SUNDRY NOTICES AND REPORTS ON WELLS

No.1 Schalk 62

Re: Permanent Abandonment

CONDITIONS OF APPROVAL

1 SCHALK 62
sec. 33, T. 32 N. R. 5 W.

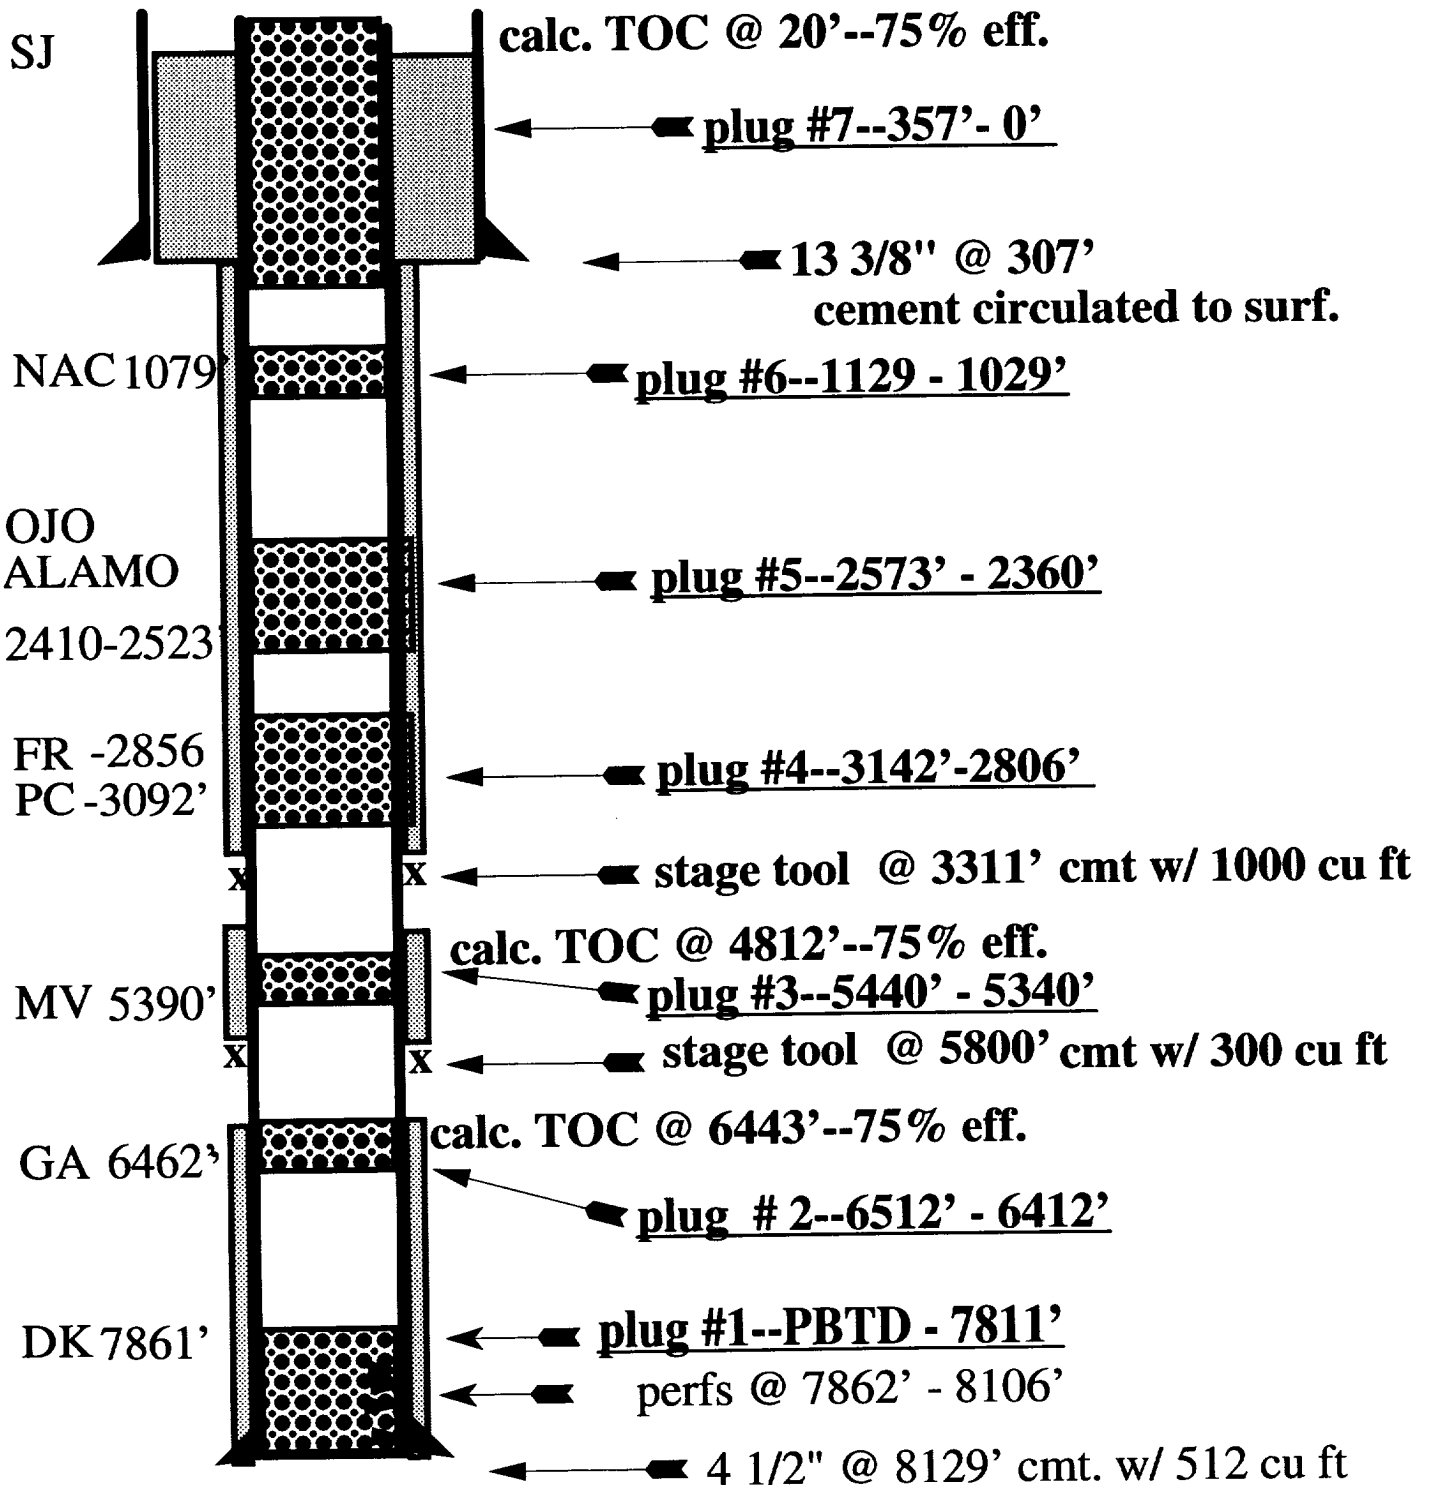
1. Drill out CIBP @ 6318', RIH with tubing opened ended and spot a cement plug from PBTD to 7811', WOC and tag top of cement plug. (Setting a CIBP or cement retainer at 7812' and spotting 50' of cement on top is acceptable, if the tight spot in the casing is repaired at 6369')

2. Spot cement plugs inside the casing at the following depths:

- A.) 6512' to 6412' -- Gallup top @ 6462'
- B.) 5440' to 5340' -- Mesaverde top @ 5390'
- C.) 3142' to 2806' -- PC to @ 3092' , FR top @ 2856'
- D.) 2573' to 2360' -- Ojo Alamo bottom @ 2523', top @ 2410'
- E.) 1129' to 1029' -- Nacimiento top @ 1079'
- F.) 357' to surface

3. Attempt to establish an injection rate down the 4 1/2" X 13 3/8" annulus (no record of cement being circulated to the surface), if a rate can be established, pump adequate cement to fill from 357' to the surface.

NOTE: attempt to pump cement down the bradenhead
